**DRAFT SUPPLEMENTAL ENVIRONMENTAL IMPACT STATEMENT
FOR THE PROPOSED
CAMPO REGIONAL LANDFILL PROJECT**

COMMENTS

Victor M. Ponce

05 May 2010

Fig. 26 New ground level after landfill closure (click on figure to enlarge)
(Bureau of Indian Affairs, 2010).

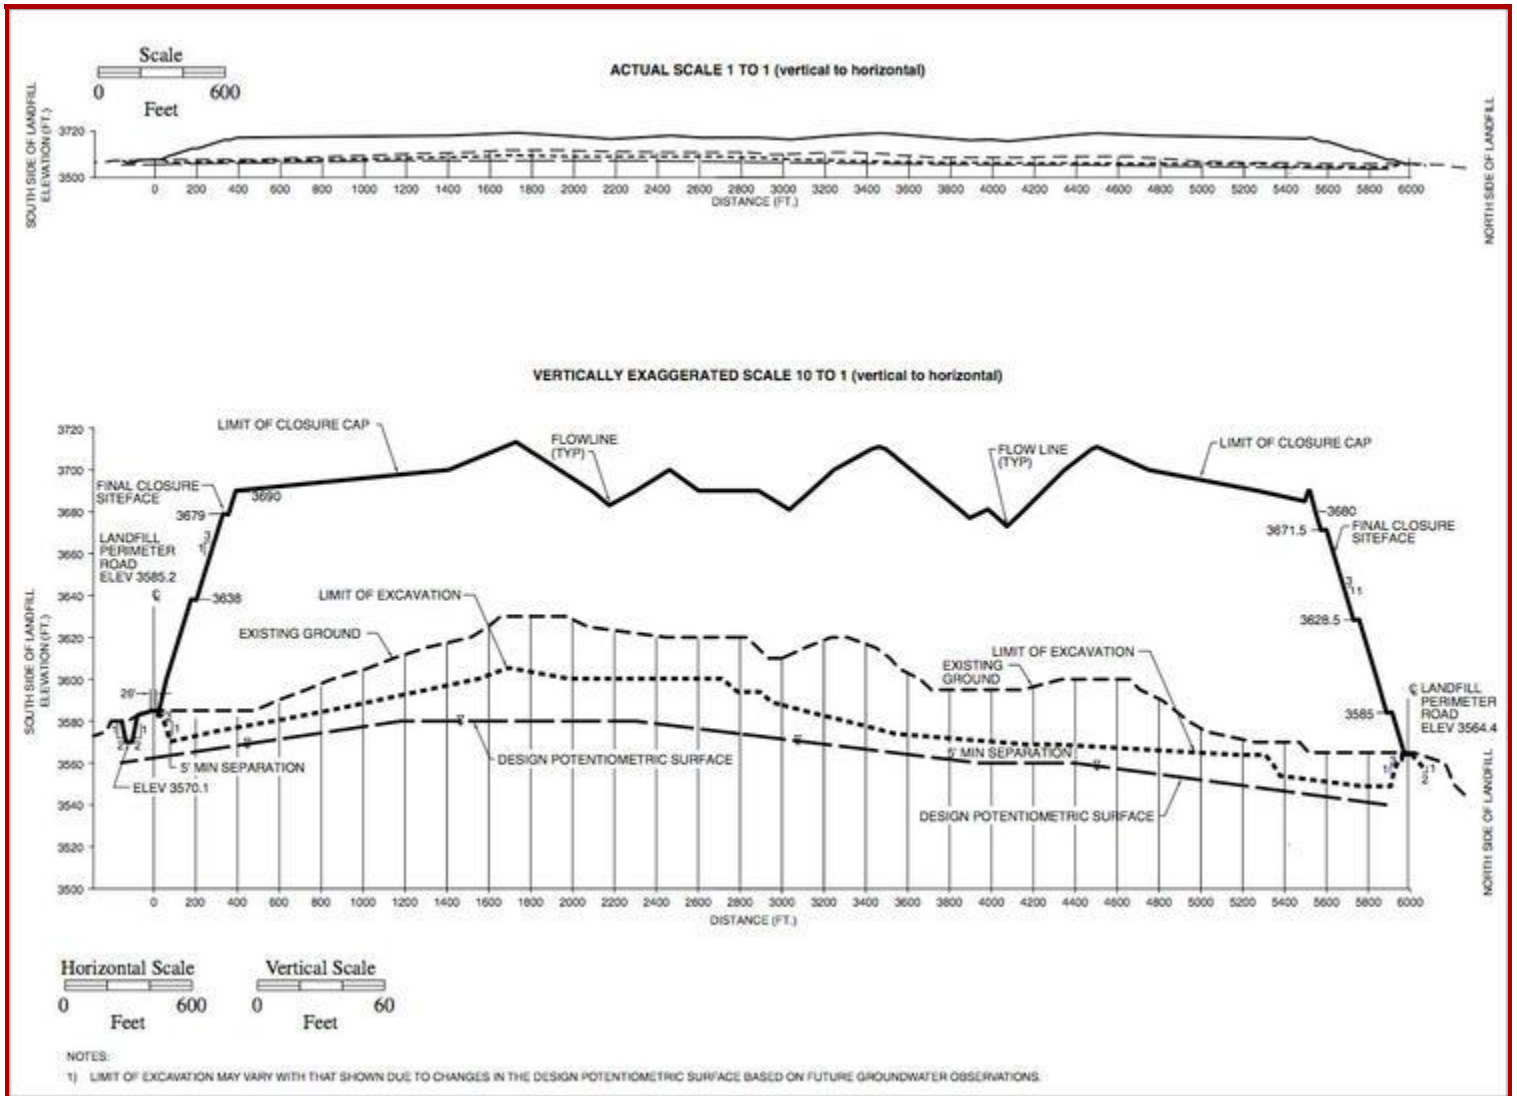
Once completed, the landfill site will increase the average ground elevation by about 100 ft, as shown in Fig. 26 (Bureau of Indian Affairs, 2010; p. 2.37). This is a direct result of placing the landfill on the headwaters of Lower Campo Creek, where it can be seen from all nearby areas, particularly from the east. It is noted that the vertical distance of 100 feet represents the height of a 10-story building.
